FISH DISTRIBUTION DATABASE CATALOG/ATLAS
CORRECTION FORM

MAP: Norton Bay D-1

WATERWAY NUMBER: 333-40-10700-2678

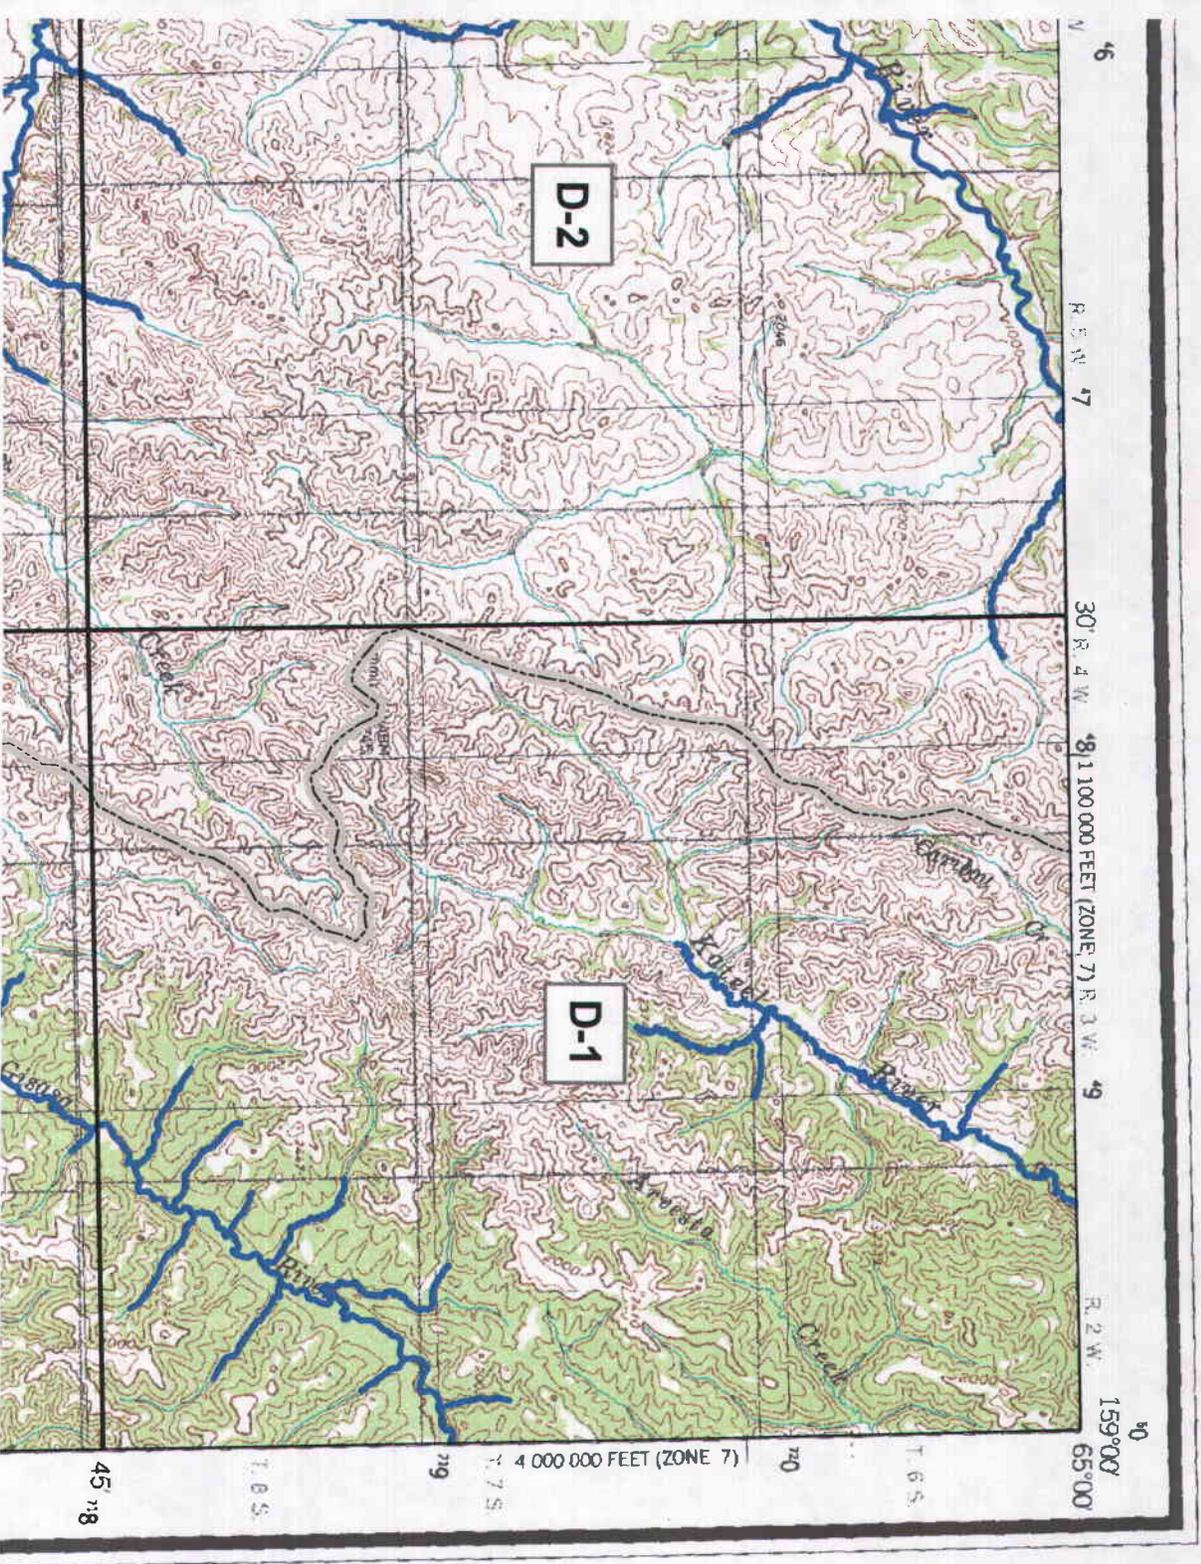
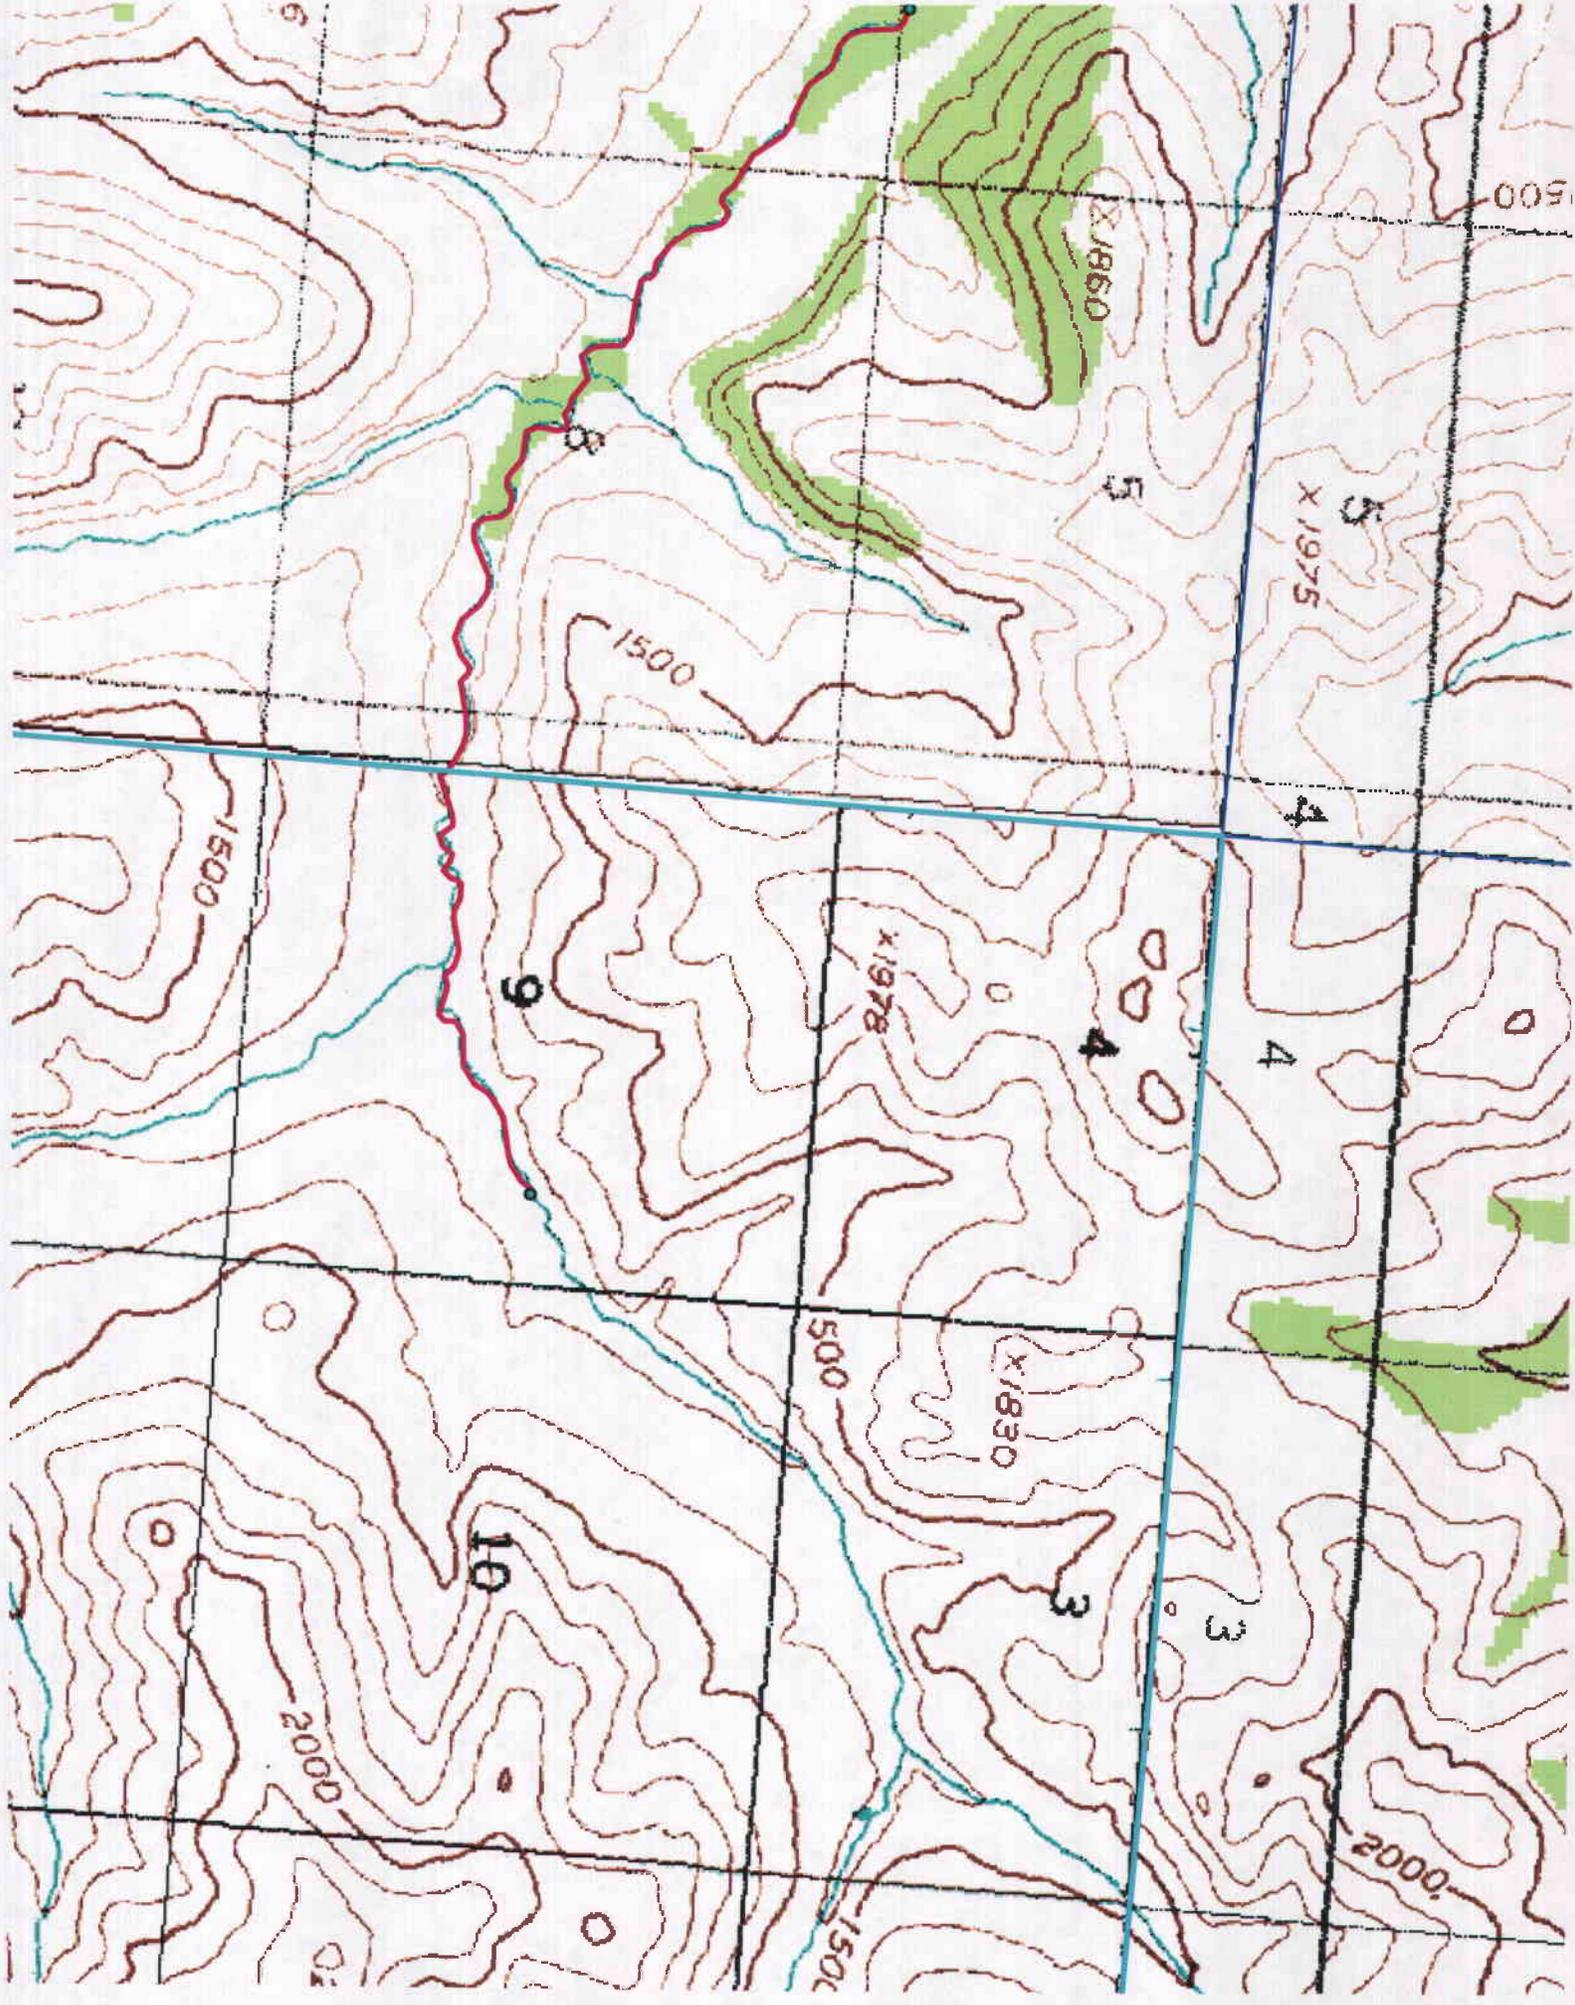
DESCRIBE CHANGE(S): arc left off map

Per our conversation, the apparent mistake I found is on the Norton Bay D-1 quad, stream # 333-40-107-2878. The stream is in the Arctic region and had appeared on the older 4/25/05 map which showed the streams in both regions. However, the new map, 3/24/06, only shows the Interior Region streams not this single stream on the Arctic side of the line. I checked the Catalog and database and it still appears in the Catalog and IMS data. The Norton Bay map I have for the Arctic Region shows the same thing no stream. Once you figure out what the problem is a note should also go out to the area Habitat and other bios letting them know that the stream is still catalog but that it doesn't appear on the map.

1:250,000 is correct
